STATE OF OREGON
WATER RESOURCES DEPARTMENT

REQUEST FOR VARIANCE OR EXCEPTION TO THE RULES AND REGULATIONS
FOR CONSTRUCTION OF A WATER WELL*.

(2) Location of Well: SE 1/4 SW 1/4 of Section 21, Township 34S
Range 8E, Klamath County.

(8) A diagram showing the pertinent features of the proposed well design and construction (attach additional sheet if necessary):

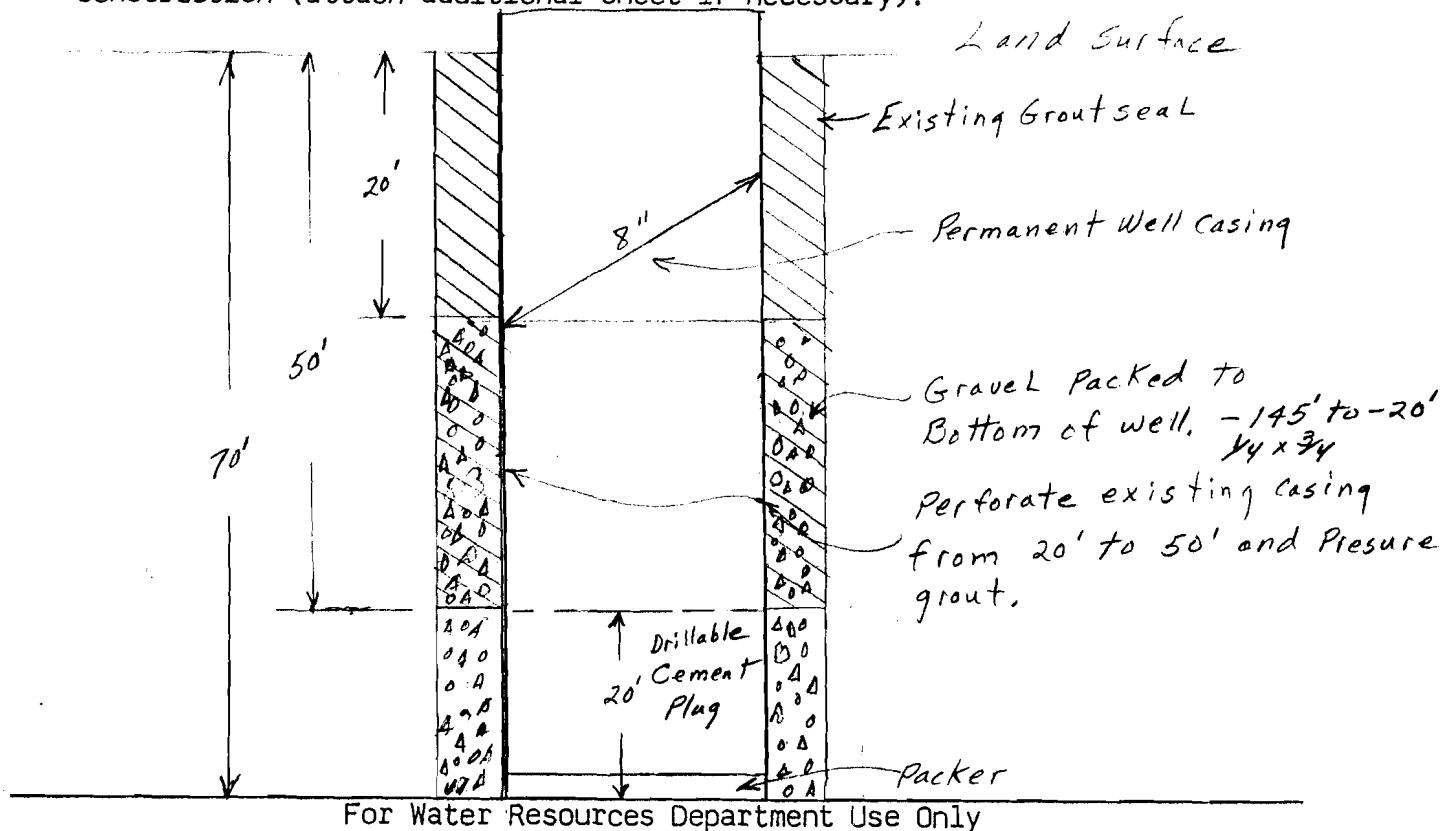
(5) The unusual conditions existing at the well site: Well needs to
be re-sealed to 50' due to the pressure of the
high SWL @ 6'4". This will keep the water from moving
up the outside of the casing and escaping into the 24' to 34'

(6) The reasons that compliance to the rules and regulations for minimum ^{permeable} standards will not result in a satisfactory well: layer.

- (1.) Place a drillable plug at 70'. (2.) Backfill with Cement to 50'. (3.) Let it set. (4.) Perforate the casing from 20' to 50'. (5.) Pressure grout the area from 20' to 50' with Cement grout. (6.) Let set completely. (7.) Drill it all out to Complete.

Denied by: J.A.C.

Remarks: Salem says Larry must hold 50 PSI for 24 hrs, with the well being gravel packed.
